BUILDING PERMIT

Permit Number: 101004

This is to certify that LIEBER ROBERT A /Property owner
has permission to build 2 story 435 sq ft Single Family Home w/ 1 bath bedroom
AT 41 DAYBERRY LN Peaks Island City 089 1005001

City of Portland, Maine - Building or Use Permit Application
 389 Congress Street, 04101 Tel: (207) 874-8703, Fax: (207) 874-8716

Site Plane

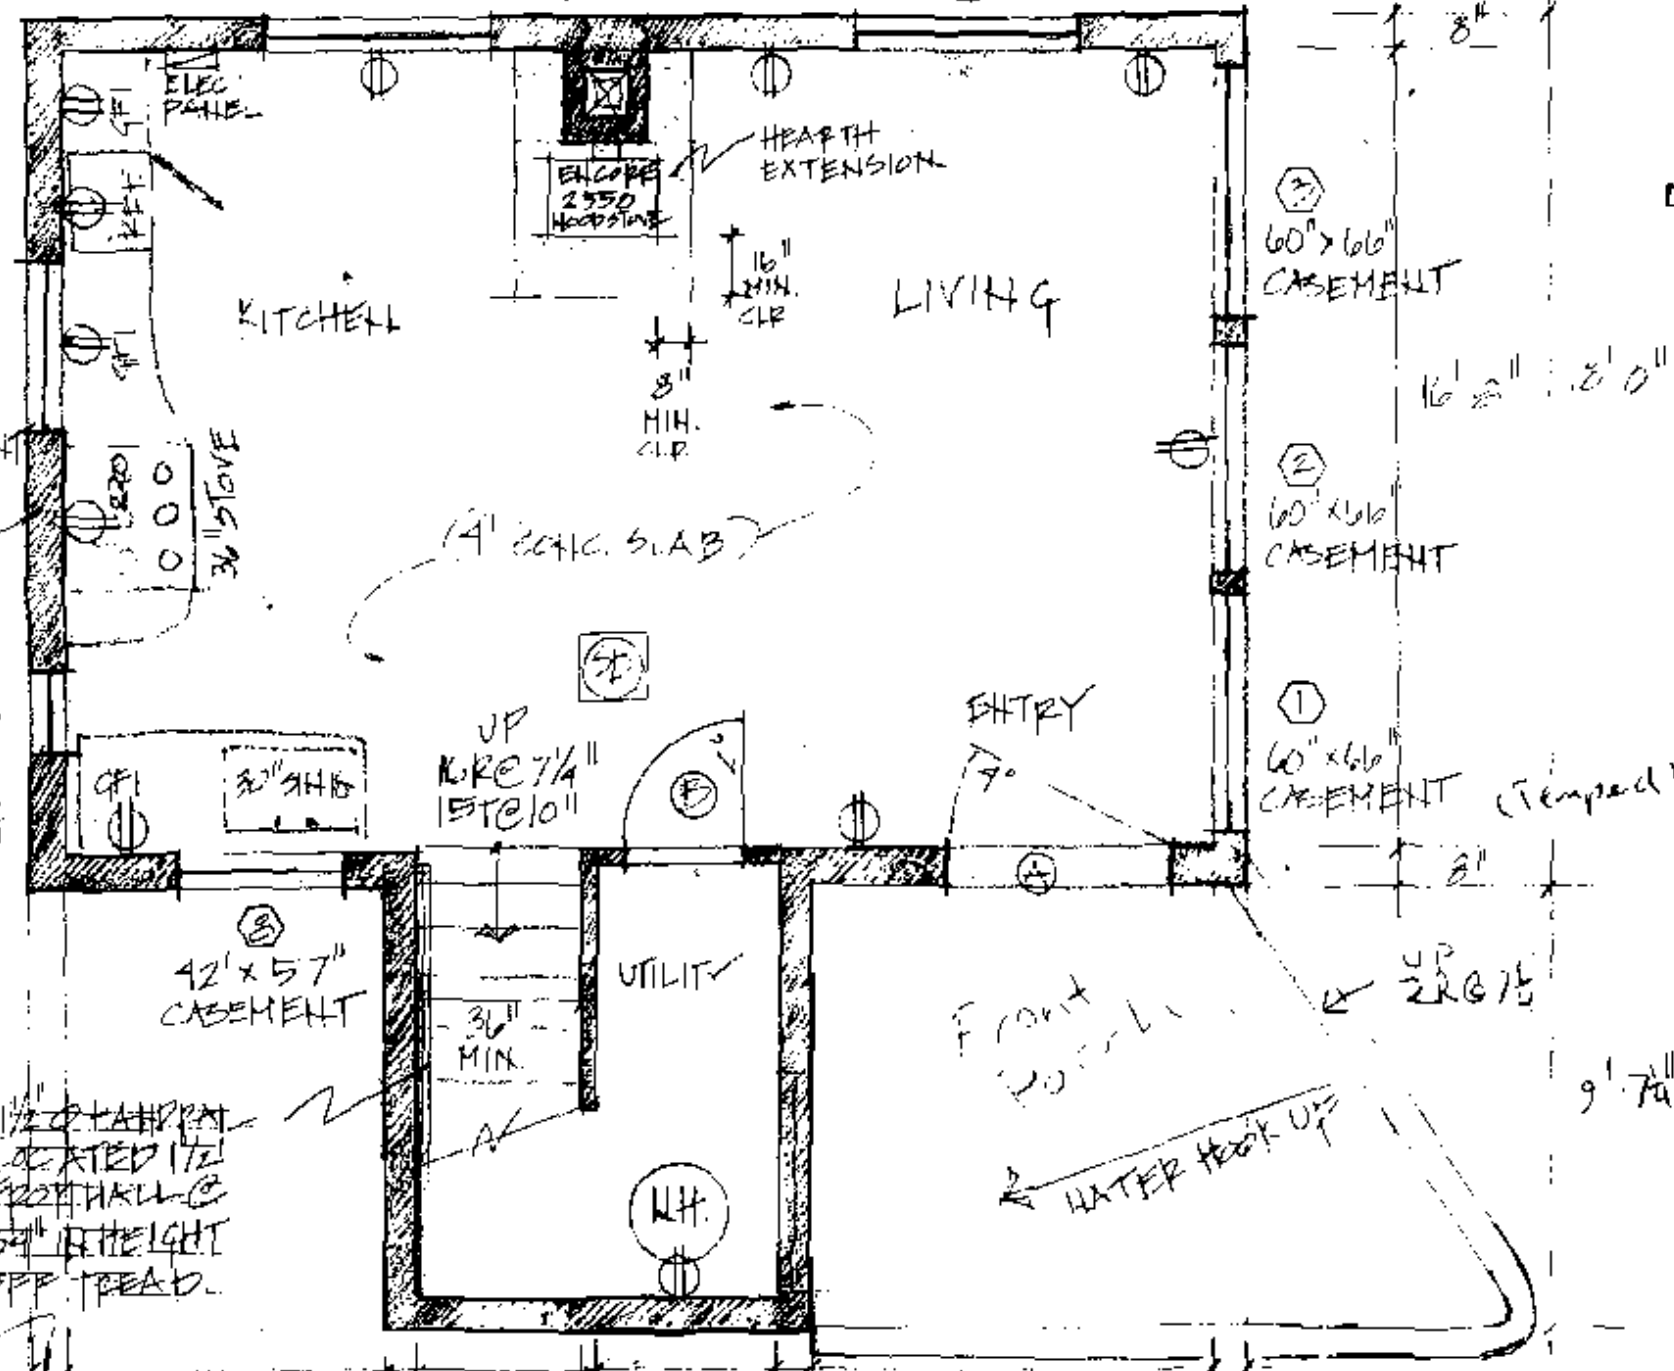
9/9/2010-amachado: Spoke to Rob Lieber. I told him that the 16' x 30' structure did not meet the rear setback. He said that it was on the master plan to be built in the future. I told him that we only wanted what was being built now on the siteplan and that he could apply for a separate permit in the future to build an accessory building, but that it would have to meet the required setbacks. I told him that he could send me something in writing stating that he was not building the accessory building at this time and that it is not part of the plan. I am moving the permit forward in the system, but I can't sign off until I get something in writing.

9/23/2010-amachado: Received revised site plan.

LIPSER RESIDENCE:
PROPOSED FIRST FLOOR PLAN

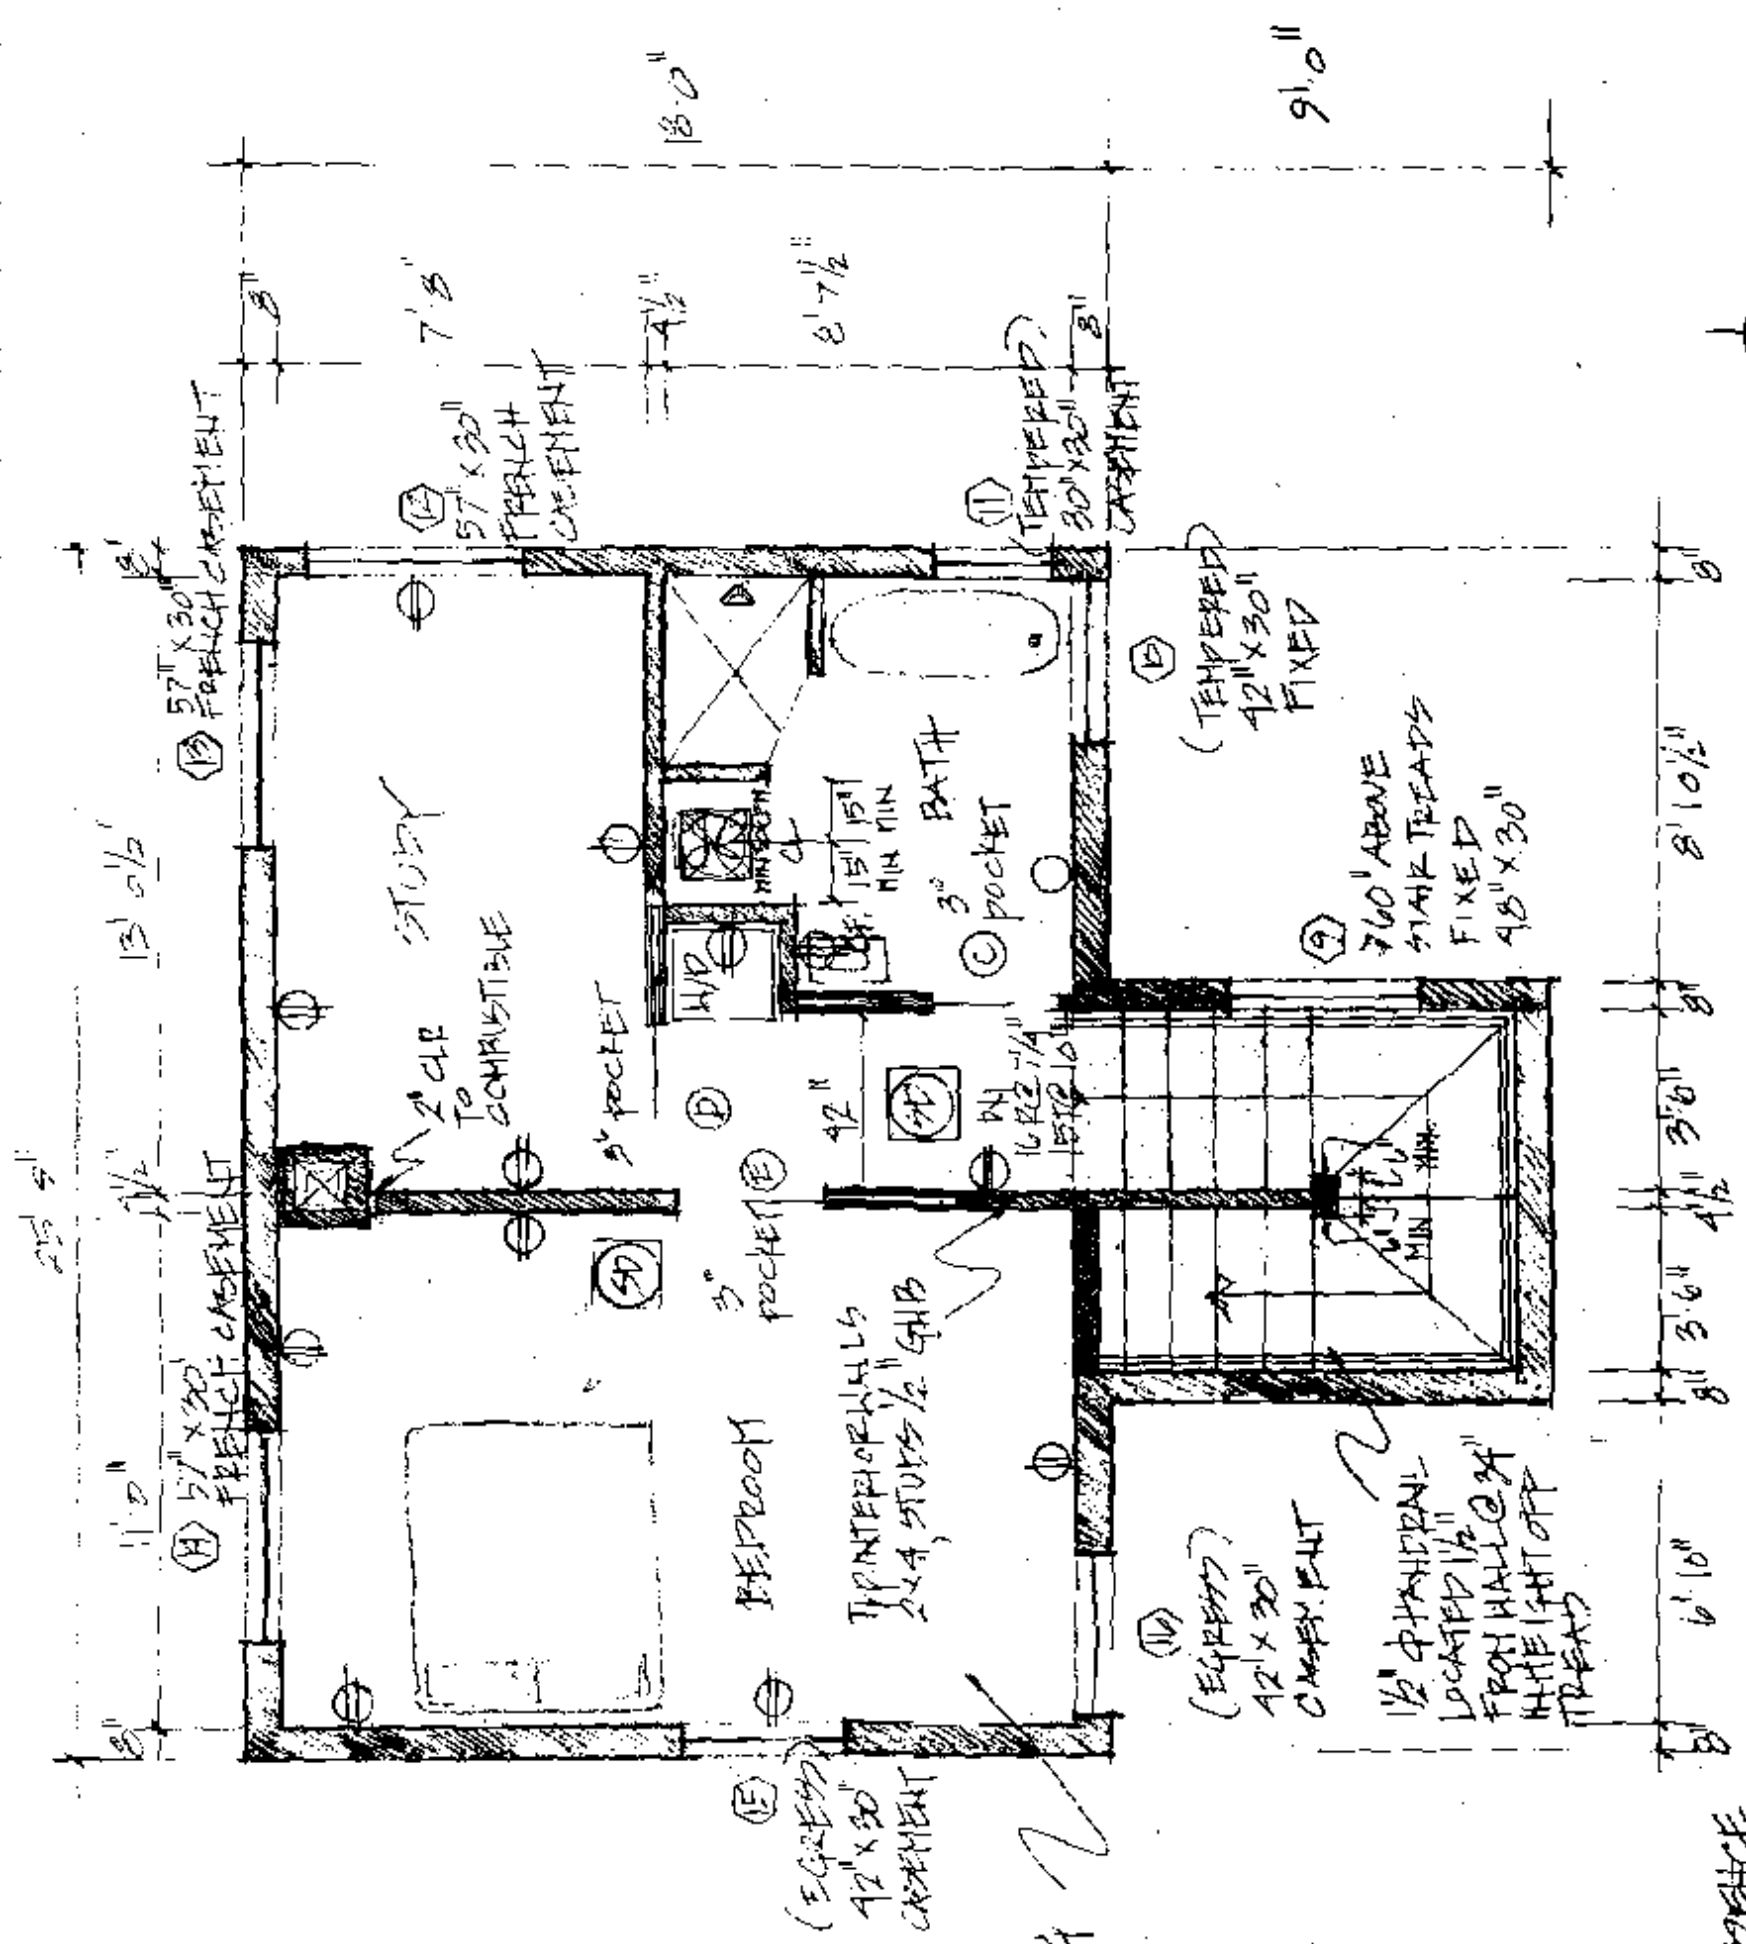
1. The first floor plan shows the hearth extension for the wood stove, will there also be a thickened footing for the chimney and hearth?

1. The first floor plan shows the hearth extension for the wood stove, will there also be a thickened footing for the chimney and hearth?
2. What will the roof sheathing be?
3. What is the u-factor of the windows

Yes there will be, I plan on supporting an area of 6'x6' with a large footing pinned to ledge under the woodstove. I am making the area 6' X 6' for a possible future masonry heater.
